**Downtown Evanston Civic Plaza Plan,
Engagement, Design, and Implementation**

RFP # 24-19

ADDENDUM No. 1

April 16, 2024

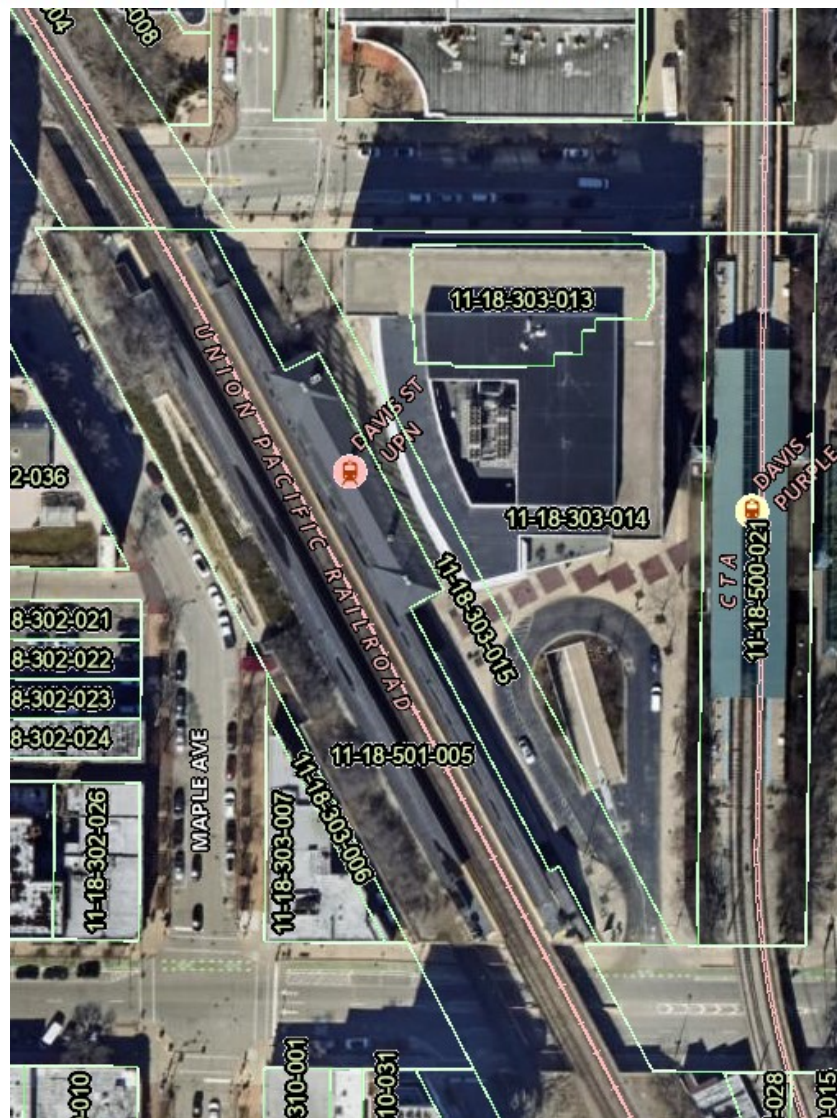
1. **Question:** During the prebid meeting, a study area map was displayed on screen that appeared to differ from the study area map included in the RFP document (page 17). Please clarify the study area for this project and please confirm who owns the land for the study area.

Response: Please use the map below, corrected to include the Union Pacific pedestrian tunnel. The map presented by staff during the presentation is not an accurate illustration of the entire study area.

In addition to the obvious CTA/Union Pacific and City properties, additional ownership is summarized in the table below. Refer to the Cook County GIS map below for specific PIN locations
